DEPARTMENT OF CITY PLANNING

RECOMMENDATION REPORT

Date:	January 25, 2018	Case No.:	CPC-2016-2248-GPA-VZC-HD-SP-CU-ZV-WDI
Time:	After 8:30 a.m.*	CEQA No.:	ENV-2016-1662-EIR (Sch. No. 2016071041)
Place:	Van Nuys City Hall 14410 Sylvan Street, Room 201 Van Nuys CA 91401	Incidental Cases:	N/A
Public Hearing:	November 14, 2017	Related Cases:	VTT-74314
Appeal Status:	General Plan Amendment and Specific Plan Amendment not appealable. The Vesting Zone Change and Height District Change are appealable only by the Applicant to City Council if disapproved in whole or in part. All other actions are appealable to the City Council per LAMC Section 12.36-C.	Council No.:	3 – Blumenfield
Expiration Date:	January 25, 2018 (Pursuant to Extension)	Plan Area:	Encino-Tarzana
Multiple Approvals:	General Plan Amendment; Vesting Zone Change; Height District Change; Specific Plan Amendment; Conditional Use; Zone Variance; and Waiver of Dedications and Improvements.	Specific Plan:	Ventura-Cahuenga Boulevard Corridor Specific Plan

PROJECT LOCATION:	18321 W. Clark Street; 18365 W. Clark Street; 18411 W. Clark Street; 18370 W. Burbank Boulevard; 18410 W. Burbank Boulevard; 18420 W. Burbank Boulevard; APN 2160

NEW PARKING STRUCTURE ELEVATIONS

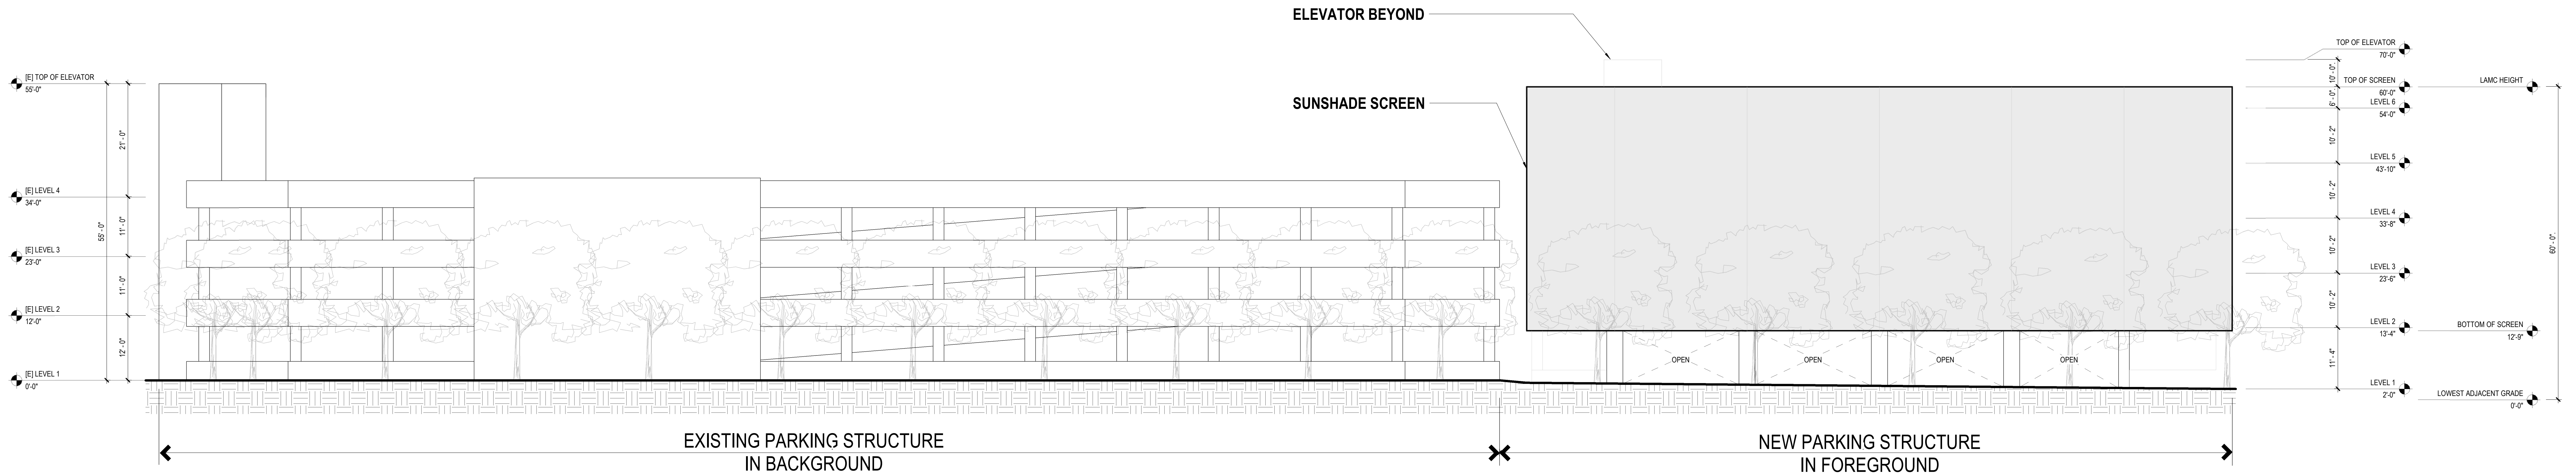
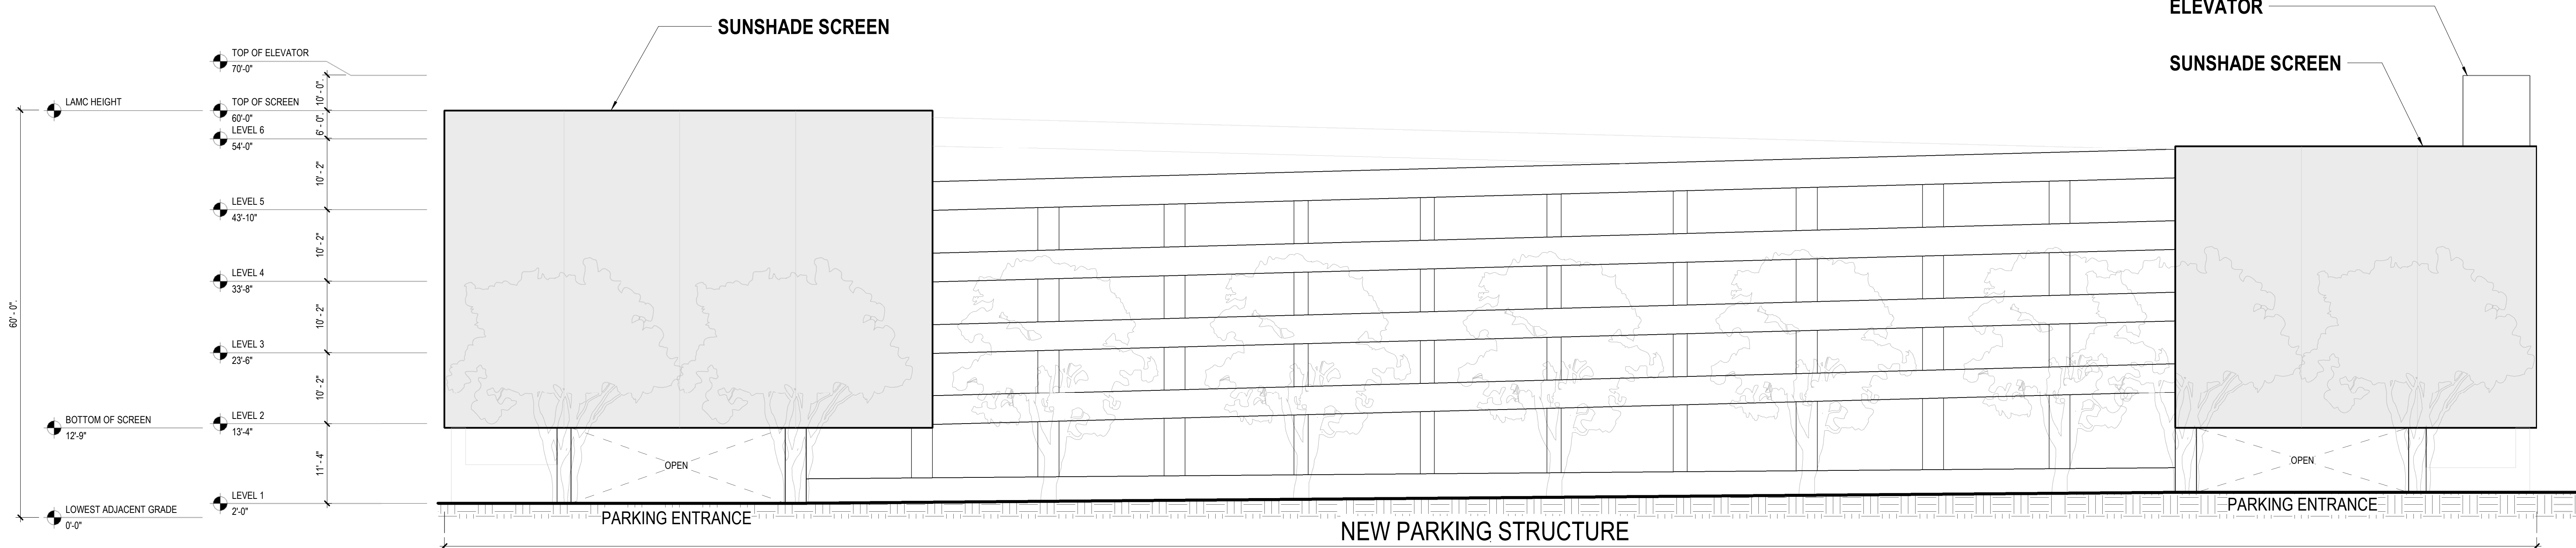
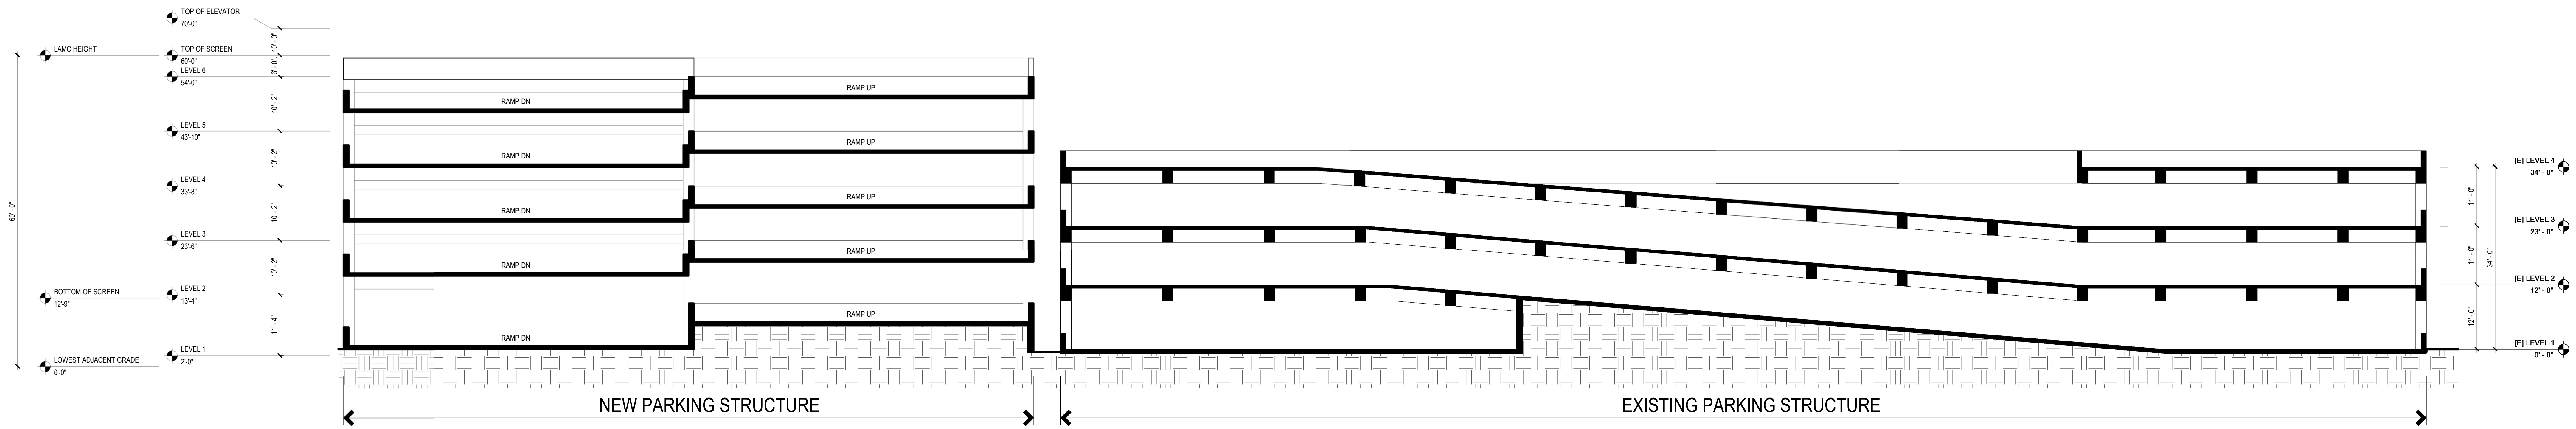
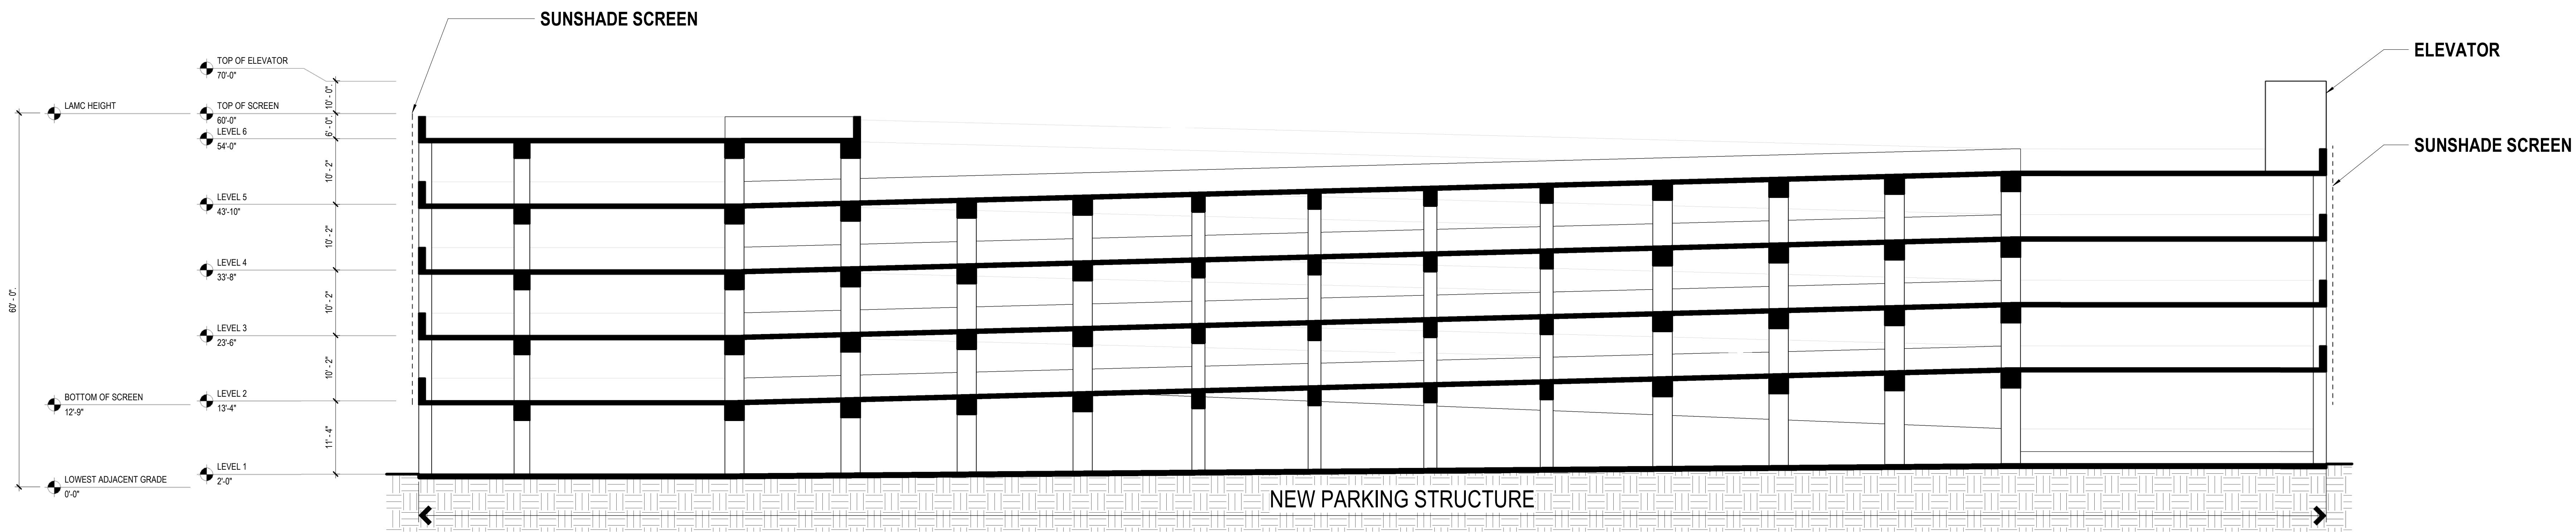
- *Do not show horizontal ramps on parking structure - they can easily be screened with architectural features.*

or copper planes of the colors of the Patient Wing. Could have a mesh that curves up such undulating waves from edge.

The New Parking Structure has been redesigned to reduce the view of the horizontal ramps. The New Parking Structure has been redesigned along the western elevation to utilize the adjacent grade and slope. The ground floor has been modified to mimic the adjacent grade and one percent slope. Drivers and pedestrians within the surface parking to the west of the New Parking Structure would perceive the ground floor level as flat. Ramps along the western elevation for the elevated levels would slope about 1.5 percent more and would be parallel with each other, and the steeper ramps have been relocated to the east elevation adjacent to the Existing Parking Structure. The design utilizes the adjacent grade and slope to create a natural, "flat" feel to the look of the floors from the perspective of the drivers and pedestrians within the surface parking lot to the west of the New Parking Structure and drivers who may glimpse the New Parking Structure from Burbank Boulevard.

As described above, the Parking Structures are tertiary elements within the Medical Center. These structures are intentionally designed to recede into the background and remain rectilinear in plan and elevation. New Parking Structure is designed to complement, but not compete in form and aesthetic with, the New Patient Wing.
